PLANNING BOARD MEETING

Tuesday, February 20, 2024 at 6:00 PM

1. Site Plan & Design Review - Short Street

9 SHORT STREET REAR YARD MODIFICATION RANDOLPH, MASSACHUSETTS

LATEST REVISION:

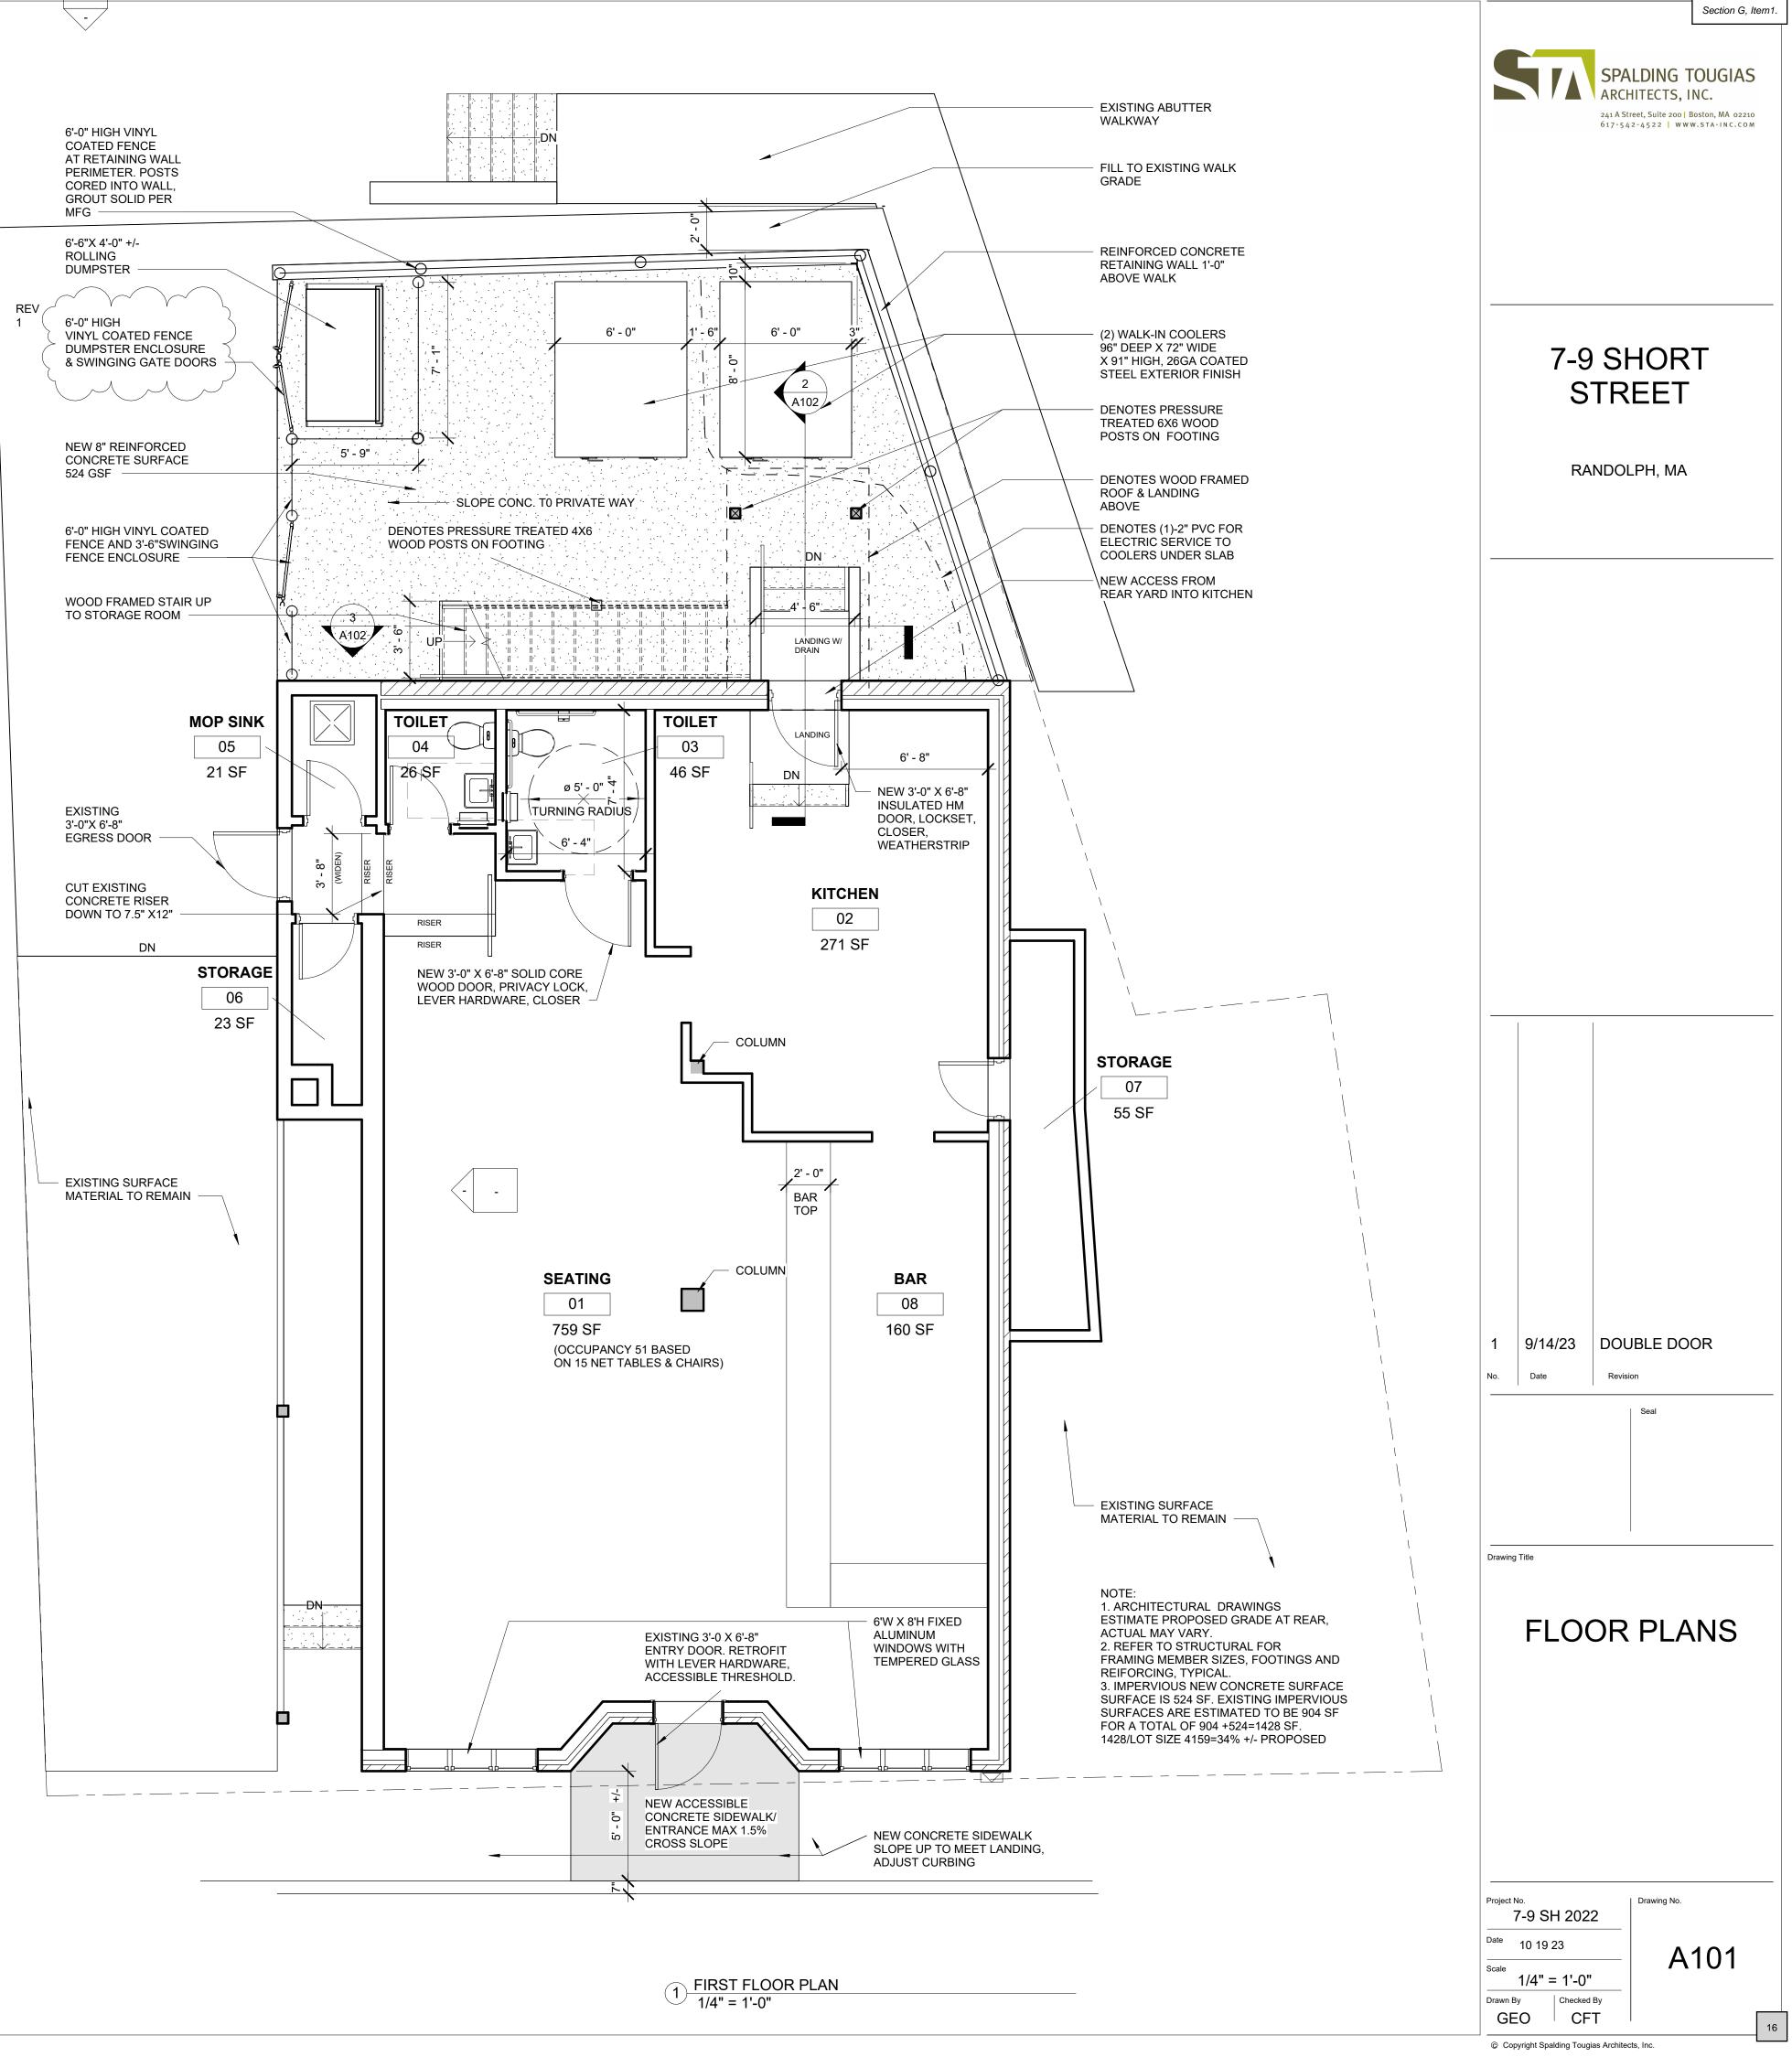
- a. Pictorial renderings (page 4) depict a new door on the eastern side of the structure but there is no corresponding reference on the civil plans A-101). Either the civil plan or the pictorial renderings submitted should be correct to accurately indicate the intent.
- b. The plan set (A-101) indicated concrete sloping to a "private way". There is no private way associated with the parcel. Plan notes should be corrected.
- c. The plan set (A-101) indicates the fencing is vinyl coated fence but the narrative with spec sheets calls out a fence panel. Either the civil plan or the pictorial renderings submitted should be correct to accurately indicate the intent.
- d. The plan set (A-101) calls out a drain at the landing but no plan set includes the placement of a dry well.
- e. The plans do not call out roof drains and how the run-off will be managed.
